**Project Questions and Answers - 8/5/24**  
Rifle Falls SFU – Isolation Building

## Project Questions and Answers - 8/5/24 Rifle Falls SFU – Isolation Building

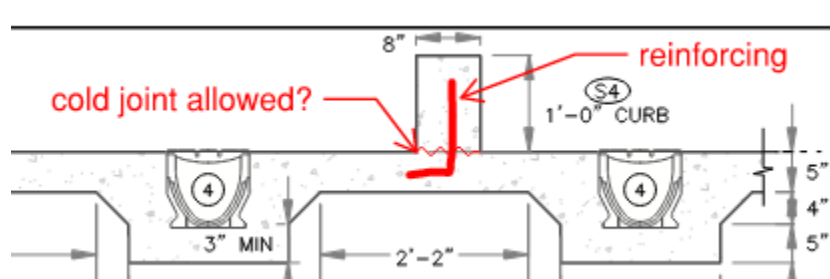
8. Question: Is a cold joint allowed where the curb meets the interior slab provided it's tied in with dowels? (see image)

Answer: The construction method shown above will be allowed, and any costs should be included in Bid Item 7 - Concrete Slab. Reinforcement size and spacing is to be approved by the Project Manager.

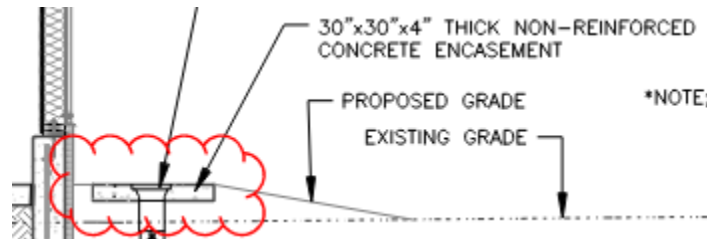
9. Question: Please clarify the height of the curb mentioned in previous question. Image below calls out an 8" w x 10" high curb but detail B/6-6 shows 1' tall.

10. Question: Please verify that the only reinforcing in the slabs is 7.5lbs/cy of fiber and no rebar.

Answer: The callout shown on the referenced image from the foundation plan indicates an incorrect dimension. The interior concrete curb, S4 is to be 8" wide x 12" tall. See Addendum No. 1.

Answer: That is correct. See bid documents for reinforcement requirements.
